Interactive comment on “Investigating uncertainty of climate change effect on entering runoff to Urmia Lake Iran” by P. Razmara et al.

P. Razmara et al.

Received and published: 24 June 2013

Fig. 1.

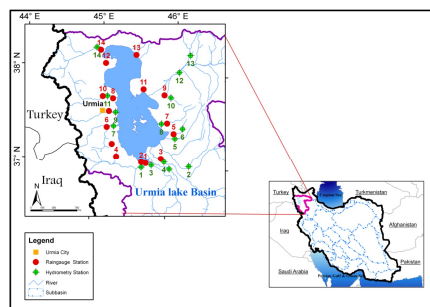
9. There are several problems with Figure 1. Firstly, the figure panels are too small and it is very difficult to make out the station labels and the names of adjoining countries. Secondly, the authors should mention in the caption that hydro meteorological and rain gauge stations are marked on the map. Thirdly, it may be easier for the reader to get a sense of the runoff inputs to Urmia Lake if only the major inflowing rivers were marked and not all of the lower order streams. Lastly, in the panel showing all of Iran, it is unclear what the boundaries and colors represent. I presume they are other watersheds and if so, this should be mentioned in the caption.

Answer: The figure was corrected and has been shown again. The hydro meteorological and rain gauge stations are mentioned in the caption and all of your comment was noticed.

Fig. 2.

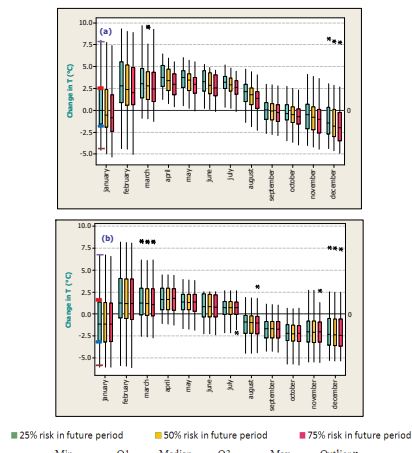
22. Figures 2 and 3 are both too small and the labels are difficult to read. In both figures, the red titles should be removed and all information about the plots should be moved to the captions. Also, I suggest that the boxes for the 25, 50 and 75 % levels should be given a unique color instead of labeling them on the cluttered x-axis. Lastly, both figures would benefit from a thin horizontal line being added at the 0 mark, so that the changes in temperature and precipitation can be more easily interpreted by the reader.

23. In the second paragraph of section 4.1, I find the author's description of Figures 2 and 3 confusing. In the text, they refer to the median temperature change, but the figure titles refer to the mean. I also find the phrase "mean of maximum temperature changes" confusing. I think the clarity of this whole paragraph (P2195, L19 to P2196, L6) needs improvement.

Answer: Figures 2 and 3 were drawn again.

Answer: Ok, it was corrected.

Fig. 4.

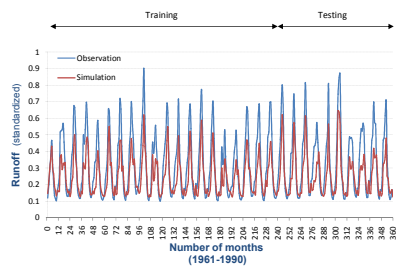
25. The axis titles and labels in Figure 4 are too small. The x and y axis titles are also very vague... make them more specific. I also suggest that the two lines have different colors and be properly labeled in the legend.

Answer: Figure 4 was drawn again.

Fig. 5.

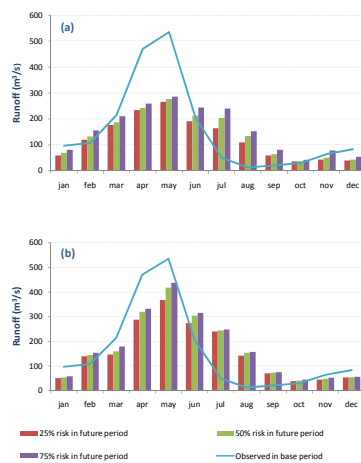
26. Label the two panels in Figure 5 with an "a" and "b". Superscript the "3" in the y-axis units. Label the "future period" and "base period" data in the legend.

P2197, L6: Change "... (left and right)..." to "... (Figure 5a,b)..." Label the panels in Figure 5 accordingly.

Answer: ok. This figure was corrected as you asked.

Answer: Ok, the figure was corrected.
